**PROTERRA**

# TECHNICAL SERVICE BULLETIN

<b>ISSUE DATE:</b>	1-21-2021
<b>SERVICE BULLETIN SUBJECT:</b>	Duopower Gearbox Lock Washer Retrofit
<b>VINs or MODELS AFFECTED:</b>	Service Specified Buses
<b>COMPLETE BY:</b>	Next Service Opportunity
<b>SERVICE BULLETIN #:</b>	SC-21-8
<b>Labor Operation Code:</b>	PP43Z

## **DUOPOWER GEARBOX LOCK WASHER RETROFIT**

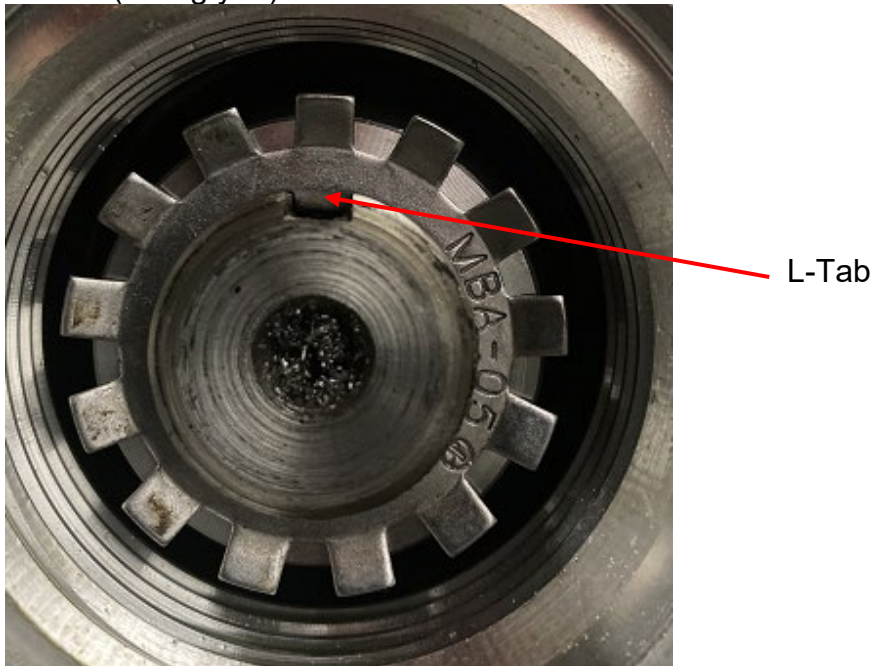
11. Using a 1/2-Inch Drive Pull Handle with a TMFS 5 Socket, remove the Lock Nut.
12. Inspect the removed Lock Washer. Is the ID Tab within the axel shaft keyway? Is the ID Tab Damaged? If the Lock Washer is damaged, take a photograph of it and email it to [jotto@proterra.com](mailto:jotto@proterra.com).
13. If the ID Tab of the Lock Washer is not in the keyway, rotate it until it is.
14. Using Needle Nose Pliers, remove the Lock Washer.
15. The following photographs show the difference between the old style of Lock Washer and the new L-Tab Lock Washer (125-6417).

16. Place the Lock Washer (125-6417) into position with the L-Tab facing outward toward the Wheel Ends (facing away from you). The Outer Diameter Tabs will be facing inward toward the nut (facing you).

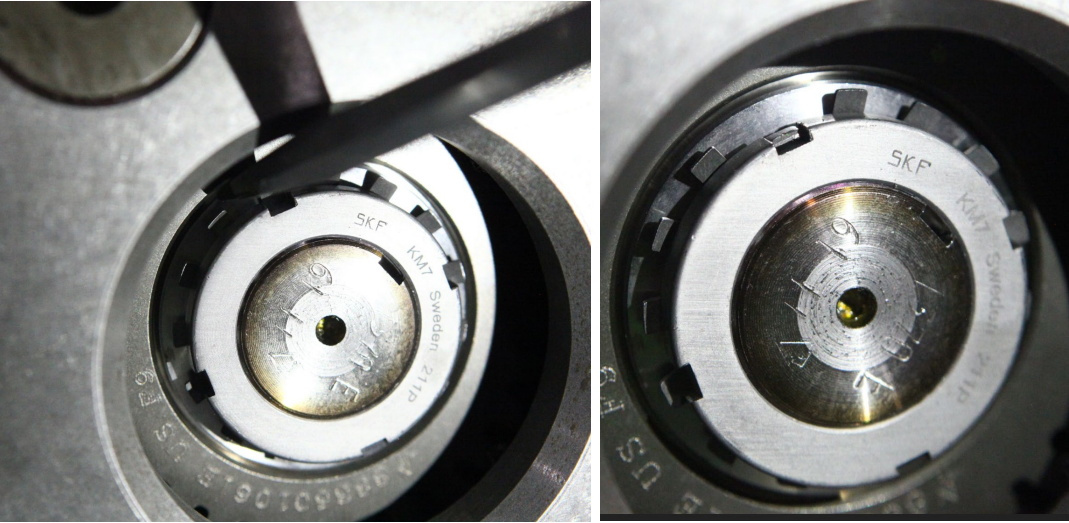
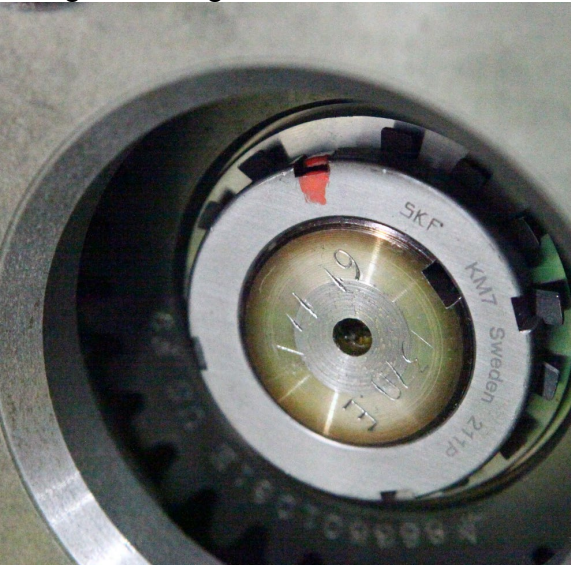
20. After torquing the Lock Nut, observe the Lock Washer (125-6417) to determine if one of the Outside Diameter Tabs aligns with one of the four slots in the Lock Nut.
21. If none of the Outside Diameter Tabs align with a Lock Nut Slot, continue using the Torque Wrench to tighten the Lock Nut until a Tab is in alignment. **Do not exceed 50 foot pounds of Torque.**
22. Using a Flashlight, inspect the Lock Washer (125-6417) for damage. If the Lock Washer is damaged, it must be replaced with one of the spares from the kit.
23. Using a Flat Blade Screwdriver or a Pick, bend the Outside Diameter Tab into the slot on the Lock Nut.

24. Using an Orange Paint Pen, mark the bent Tab.
